Access Compliance Report

Public Rights-of-Way

Intersection ID: 31352	Main Street: MCINTYRE_RIDGE_DR	Cross Street: TRULL_ST	Location: SW
ADA ID: 568C324E4103	Ramp Type: BlendTrans1	Initial Pass/Fail: Fail	Overall Compliance: No
			Severity Score: 33.75

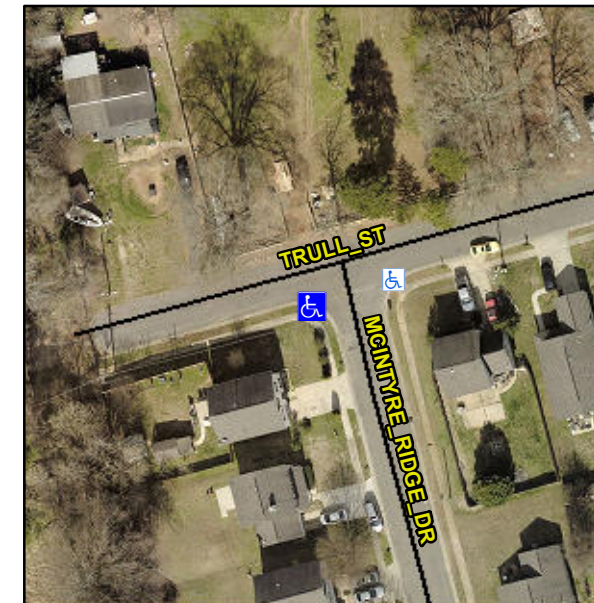
Not Found, R304.5.1, R304.5.3

Compliance	Description	Data	Compliance	Description	Data
N/A	Ramp Length (in)	46.0	Yes	BlendTrans Slope (%)	2.2
No	Ramp Width (in)	42.0	No	BlendTrans XSlope (%)	15.0
N/A	Flare Type LT	N/A	N/A	Flare Type RT	N/A
N/A	Flare Slope LT (%)	N/A	N/A	Flare Slope RT (%)	N/A
N/A	Flare Traversable LT?	N/A	N/A	Flare Traversable RT?	N/A
N/A	Landing Length (in)	N/A	N/A	DWS Provided?	N/A
N/A	Landing Width (in)	N/A	N/A	DWS Contrast?	N/A
N/A	Landing Slope (%)	N/A	N/A	DWS Length (in)	N/A
N/A	Landing X Slope (%)	N/A	N/A	DWS Full Width?	N/A
N/A	Landing Curb? (Y/N)	N/A	N/A	DWS Offset (in)	N/A
N/A	Shared Landing?	N/A			
N/A	Gutter Ponding?	N/A	N/A	Gutter Slope (%)	N/A
N/A	Gutter Lip Ht (in)	N/A	N/A	Gutter X Slope (%)	N/A
N/A	Painted X Walk1?	No	N/A	Painted X Walk2?	N/A
	X Walk 1 Direction	To NE		X Walk 2 Direction	N/A
	X Walk 1 Width (in)	N/A		X Walk 2 Width (in)	N/A
	X Walk 1 Slope (%)	3.0		X Walk 2 Slope (%)	N/A
	X Walk 1 X Slope (%)	1.9		X Walk 2 X Slope (%)	N/A

N/A	Ramp inside XWalk1?	N/A	N/A	Ramp inside XWalk2?	N/A
	Road Slope (%)	1.9		Clear Space?	N/A
	Road X Slope (%)	3.0	N/A	Clear Space to XWalk (in)	N/A
N/A	Any Obstructions?	N/A	N/A	Storm Grate/Utility Hazard?	N/A
	Obstruction Type			Storm Grate/Utility Type	
		N/A			N/A
			Yes	Surface Condition? (G/P)	Good
			No	Curb Slope (%)	13.8

Remove & Replace Curb Ramp With Two New Directional Ramps or Equivalent.
